James Blair  
San Juan National Forest  
15 Burnett Court  
Durango, CO 81301  
Submitted electronically to  
<https://cara.fs2c.usda.gov/Public//CommentInput?Project=63036>

**San Juan Citizens Alliance Comments on Catamount Spring Creek Draft EA**

Fig 1. Domestic and household use wells within the 1,000 horizontal foot buffer to the pipeline

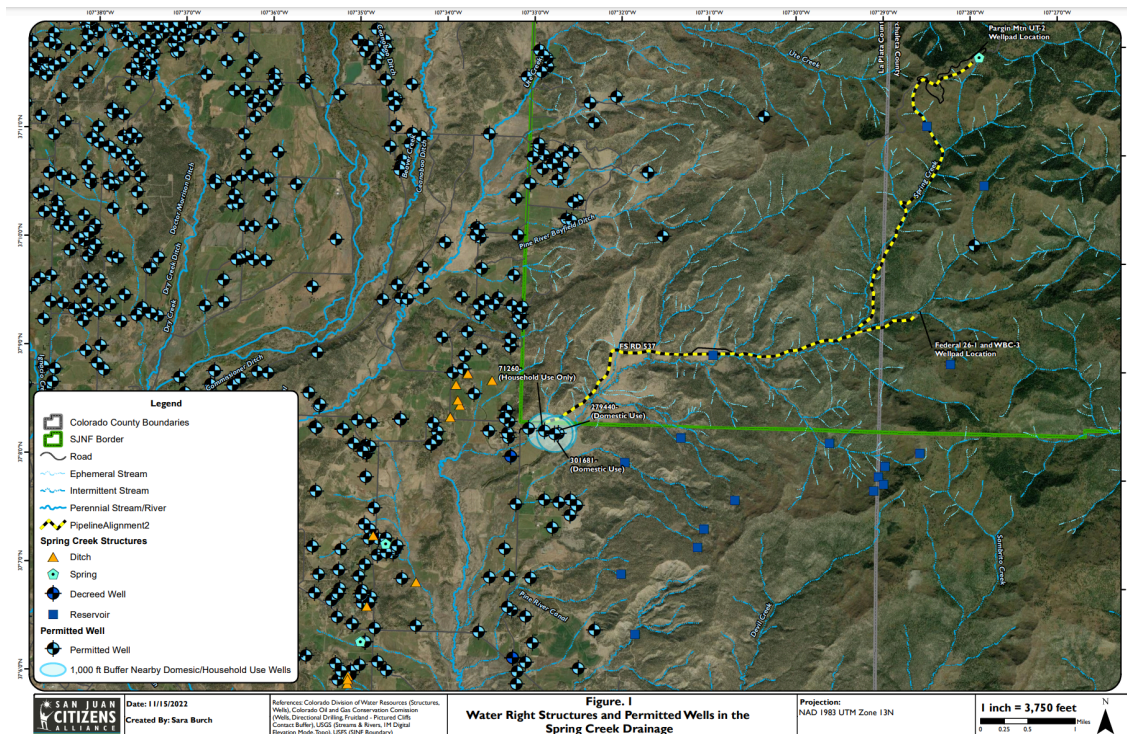
The NJSB EIS states “For all domestic water supplies using a groundwater well or spring, no surface occupancy would be allowed within a minimum distance of 1,000 horizontal feet.” We appreciate the Forest Service’s efforts to identify the 18 groundwater wells within one mile of the Proposed Action, and ensure that no water wells are located within one mile of the proposed gas wells. We reiterate, however, that the standard in the NSJB EIS is NSO within 1,000 horizontal feet of groundwater wells and springs, and that our independent mapping identified two domestic water wells within the required NSO buffer (see map below). We ask that the Forest Service consider these residential wells in its Final EA, and any opportunities to site the western terminus of the proposed pipeline to minimize risks to these resources.
